Service Bulletin

Subject: MIL ILLUMINATION WITH DTCs P219A:00 AND/OR P219B:00	Bulletin No:	01-027/13
	Last Issued:	11/12/2013

- This bulletin supersedes the previous bulletin 01-027/13, issued on 10/31/13. The REPAIR PROCEDURE has been revised.
- Changes are noted below in Red beside the change bar.

2011-2013 CX-9

Wiring Diagram:

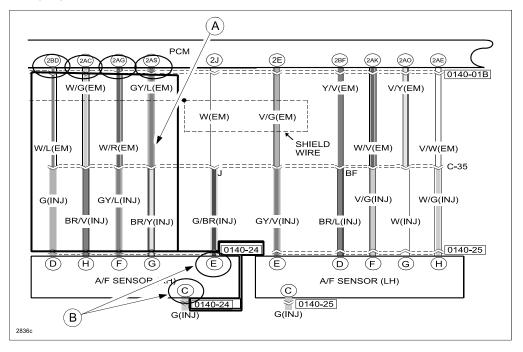
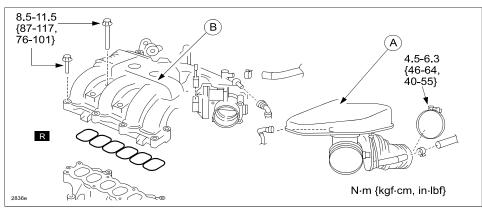
The DTCs may be caused by abnormal electrical noise within the engine harness of certain vehicles. To eliminate this concern, separate the A/F sensor signal lines from the emission harness by installing the short cord service part detailed in this bulletin.

- (A) = Install short cord
- (B) = A/F Sensor (RH) terminals C and E
